Fleet Advisory 2024-02

PSC deficiencies in Tianjin, China on 08 April 2024

PSC deficiency - Securing of Engine Room Floor Plate

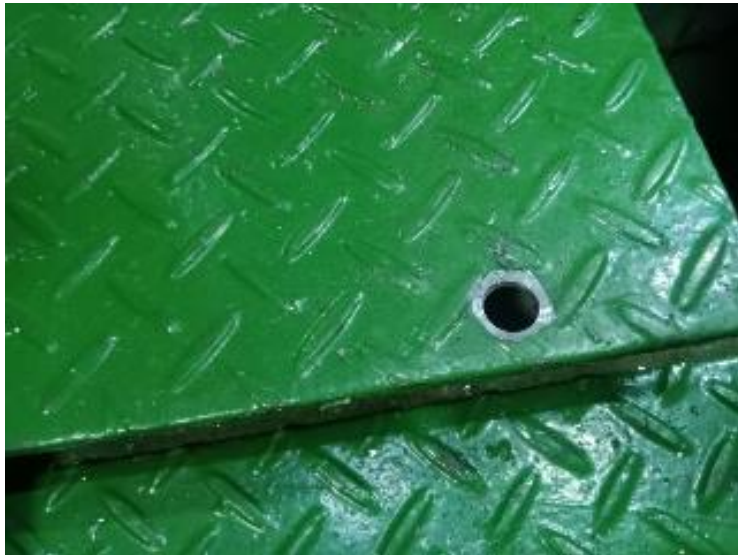
Code	Description
	<p>DEFICIENCY - Floor Plates in Engine room not secured or properly fastened. As per PSCO requirement, the floor plates in ER should be secured on the frame to avoid shifting in case of ship rolling & pitching at sea / listing / flooding.</p> <p>Company comments: It was observed that many vessels were delivered from the shipyard and the floor plates were not secured.</p> <p>Root cause:</p> <ul style="list-style-type: none">• Inadequate design• Lack of situational awareness• Inadequate identification of hazards <p>Preventive Actions: The Engine room floor plates should be secured on the frame to avoid injury to the crew . The floor plates may shift due to a) heavy rolling and pitching at sea b) listing of ship during cargo operations in port c) flooding of engine room (water sloshing the bilge area due to rolling creating a hydraulic hammer and forcing the deck plates upwards)</p> <p>Floor plates to be secured as per attached guidelines where the details of tools and brass countersunk screws to be used for securing, are provided.</p> <p>Floor plates with hinge or the sections of floor plates that need to be removed for valve operation below the floor plate should not be secured permanently by screws.</p> <p>The valve number should be stencilled on the top of these plates for easy identification of the valve underneath the plate.</p> <p>Requisition for necessary tools and screws to be raised , if not on board . The PO raised shall be informed to the Ship Manager .</p> <p>The Chief Engineer to confirm present condition and send pictures of the floor plates to the Ship Manager using picture submission form.</p> <p>Target date for compliance: 30th July 2024</p>

As per PSCO requirement, the floor plates in ER should be secured on the frame to avoid shifting in case of ship rolling & pitching at sea / listing / flooding.

At delivery from shipyard, the floor plates are not secured.

Drill holes in the plates and supporting frames with straight twist drill
(Drill Φ : 9mm)

Drill through the plate and the frame bar.

Carry out chamfering of the drilled hole on the plate.

Use the M20 straight twist drill to chamfer the hole on the plate.

Tap the drilled holes on each frame with M10 hand tap.

Secure the plates with M10 countersunk screws.

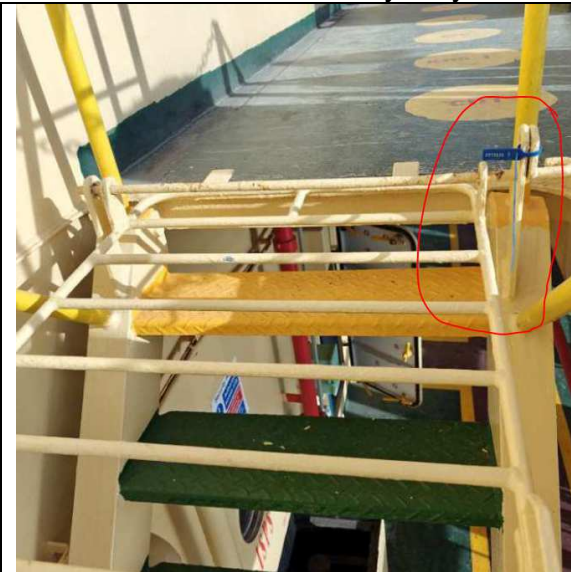
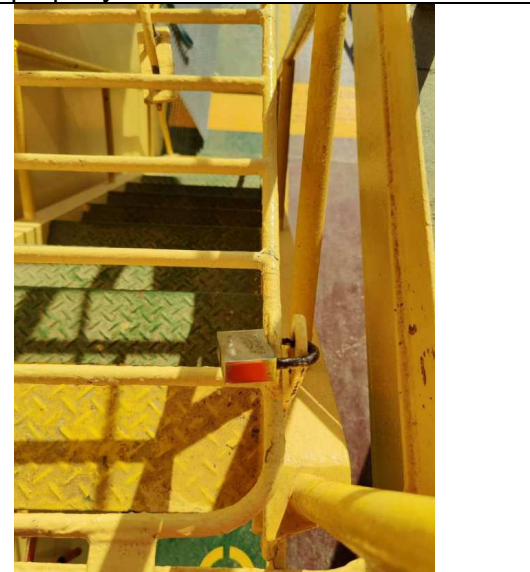
4/18327	<p>Some opening /closing devices of ventilation on outside decks are put in too high position that cannot be reached in safely because steps are missing.</p>

- If the air vents around accommodation are not reachable safely from the deck level, please inform your Ship Manager/Superintendent for installing the step below the air vent.

Step installed on deck

Step and hand hold installed on bulkhead

Fig. 2.1.3-2

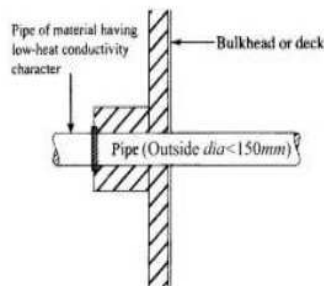
S.No. / Code	Description
1/ 0710 1	<p>Decks bulkheads and penetrations - Insulation materials for pipes from E/R to fire station on A-60 deck not extended 450mm.</p> <p>Comments:</p> <ul style="list-style-type: none"> • The insulation was not installed on the two compressed air pipes passing through the A Class floor to the fire station. • All other pipes, ducts and penetrations passing through the A-Class protection deck are to be insulated up to 450 mm. • Check pipes penetrating the A-Class division are insulated until length of 450mm. <div style="display: flex; justify-content: space-around;"> <div data-bbox="317 902 898 1305">  </div> <div data-bbox="898 902 1497 1305">  </div> </div> <div style="display: flex; justify-content: space-around; margin-top: 5px;"> Before - without insulation After - with insulation </div> <p>Following ClassNK Guidance Part R Annex R9.3.1 Fig.2.1.3-1 for quick reference in accordance with SOLAS II-2 / Reg.9.3.</p>

2 Notwithstanding 1 above, for a penetration of a pipe made of material having low-heat conductivity character (e.g. a metallic pipe) and an outside diameter of less than 150 mm in a "B" class division, the insulation may be terminated at the end of penetration piece or sleeve as required. (See Fig. 2.1.3-2)
